IEC 60335-2-35

Amendment 1

**Part 2-35:
Particular requirements for instantaneous
water heaters**

Figure 103 – Diagram for the leakage current measurement for single-phase bare-element water heaters supplied by a supply cord fitted with a plug

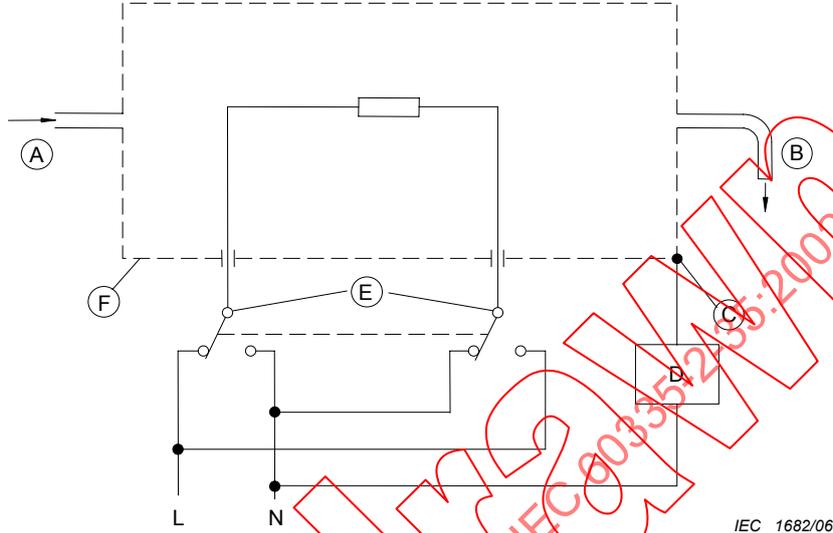
For **bare-element water heaters** intended to be connected to the power supply by a **supply cord** fitted with a plug, the leakage current test is repeated. During this test, the leakage current is measured between the earthing terminal of the appliance and the neutral conductor, as shown in Figure 103. The leakage current, measured with the selector switch in each position, shall not exceed 2,75 mA.

Add the following new figure:
